TECH NOTE

Exterior PixLine 40

Incorrect labeling, revision A, 06-28-2017

Incorrect labeling on Exterior Pixline 40

Figure 1: Incorrect label

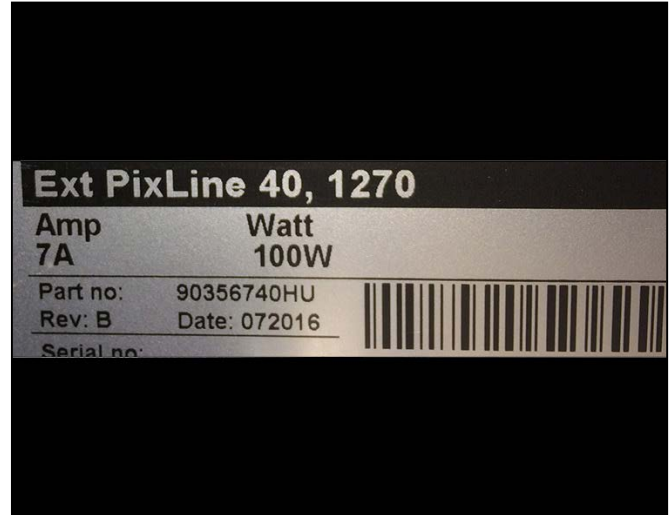
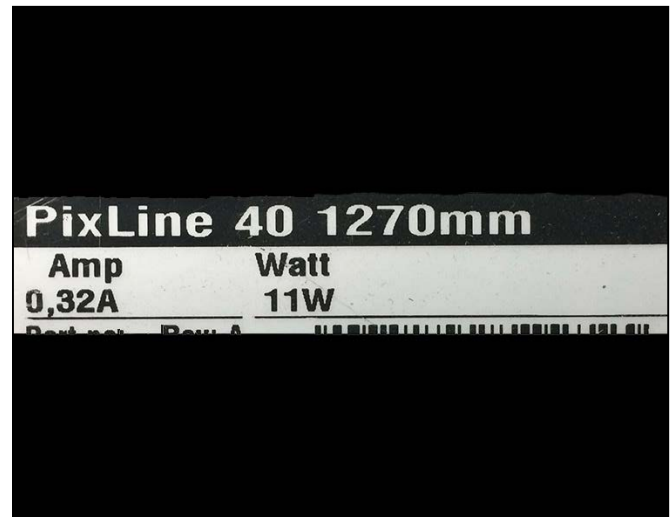
We have shipped a number of Exterior PixLine 40, 1270 mm square diffuser fixtures with incorrect information on the serial number label.

The label with the incorrect information indicated a current draw of 7 amp and a power consumption of 100 watt.

In June 2017, we have corrected this information, and products which have been shipped after this date have the correct serial number label.

- Current draw: 0.32 amp
- Power consumption: 11 watt.
